Proposal for amendments to the informal document GRRF-81-06 concerning the proposal for amendments to UN Regulation No. 55. This proposal concerns a procedure to identify allowable combinations of performance values D_c and V for drawbar coupling equipment.

Figure 28 "

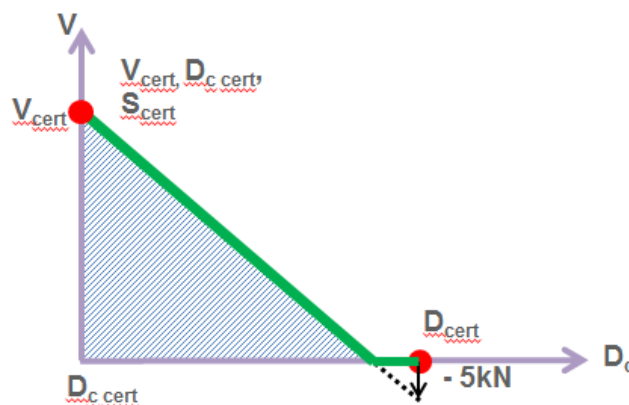
"4.1 Clevis coupling systems including drawbeams and drawbar eyes
For each combination of certified performance capacity values a diagram as shown in the Figure 28 may be drawn and [included in the user's manual]. Performance requirements D_{C-req} and V_{req} that would fall in the hatched area of the diagram are allowed to be operated in road traffic.

S_{req} shall always be below S_{cert} .

4.1.1 A component manufacturer owning a type approval certificate for a product as given in paragraph 4.1. is entitled to for that product issue a manufactures certificate certifying the safe application with D_{C-req} and V_{req} combinations laying in the hatched area. Such manufacturers certificate shall at all times be carried with the vehicle concerned.

1. Presently it is not possible to apply coupling equipment in an application where the calculated required performance values $D_{C\text{-req}}$, V_{req} and S_{req} lay in the hatched area of figure 28. I.e. any application with a $D_{C\text{req}}$ higher than $D_{C\text{cert}}$ and a V_{req} above zero is not allowed.

2. It is possible to recertify those products for application points in the hatched area. This is also done every now and then. However this procedure result in a number of alternative performance values some of which you may have on the type plate. According to the current proposal recertification would only be called for if you aim for an application above the hatched area in Figure 28.

3. This practice has been used on exemption basis with good results. The proposal has also been analysed from a theoretical standpoint applying fatigue analysis involving Haig-formalism. This has shown that the static load shall be kept at the certified value S_{cert} . Any change in S_{req} cannot be traded towards change in V-value limit. I.e. new combinations of S_{cert} shall be handled through recertification.
-
